**PRELIMINARY
STAFF REPORT
2009-2010 SOUTH COUNTY AREA PLANS REVIEW**

APR ITEM(S): 09-IV-5MV

PROPOSED PLAN AMENDMENT: See Attachment III

FIGURE 18

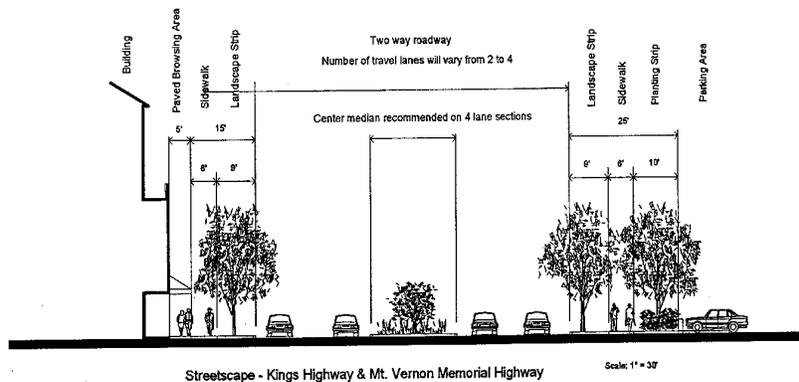
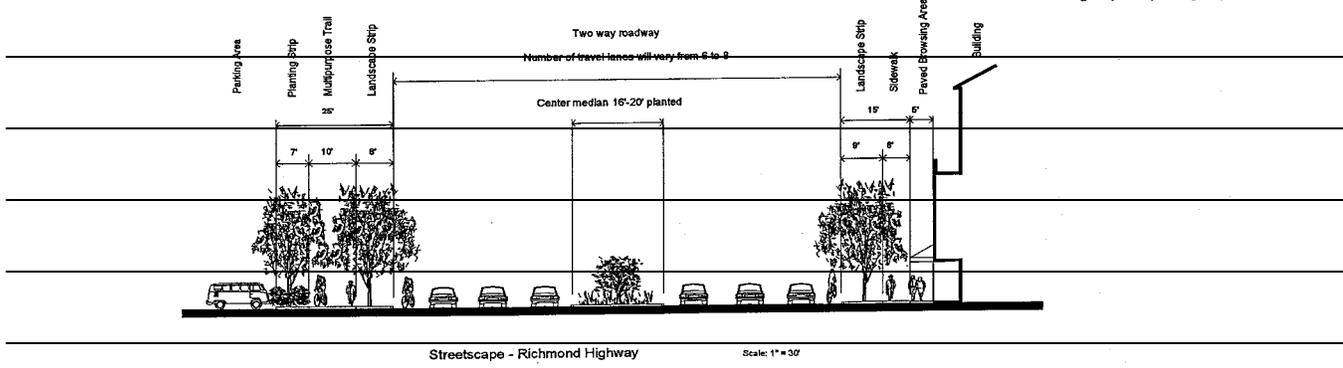
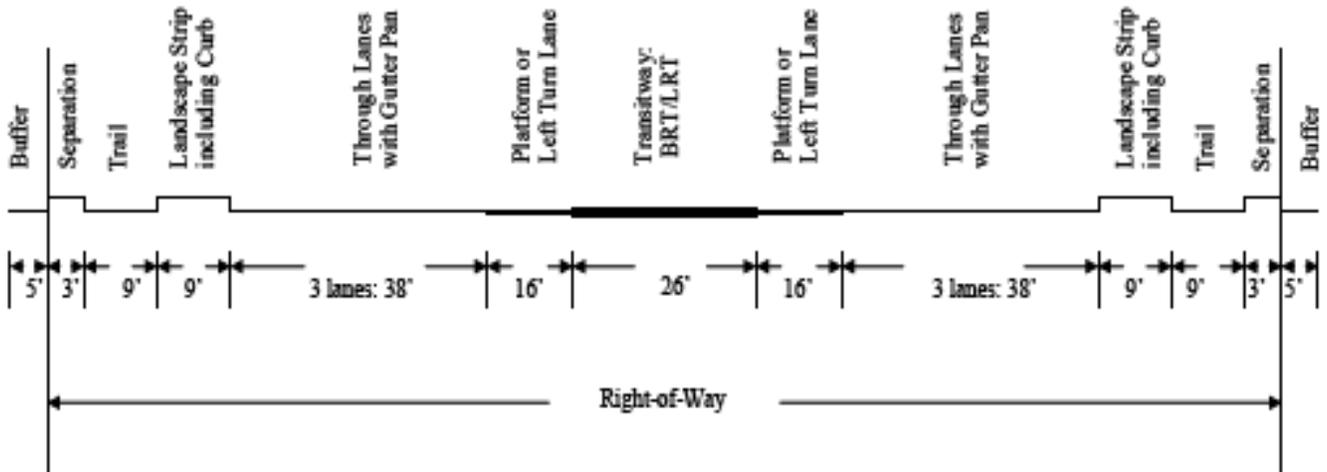
Figure 18 depicts the Cross Section/Streetscape recommendations, ~~on these prominent roadways located within the~~ for Richmond Highway. ~~Corridor area, a 20' 25' total landscape corridor width should be provided and comprised of:~~

Nominated Plan Change: Amend Richmond Highway Corridor Area Urban Design Standards to reflect current Policy Plan guidance and insert a new Figure 18 Cross Section diagram that includes updated standards for widths of the landscape corridor, curb edge, sidewalk, trail, browsing area, highway center median design and bicycle accommodation on the roadway.

Richmond Highway Cross Section
Including At-Grade Transitway in Center
(Measurement in Feet)
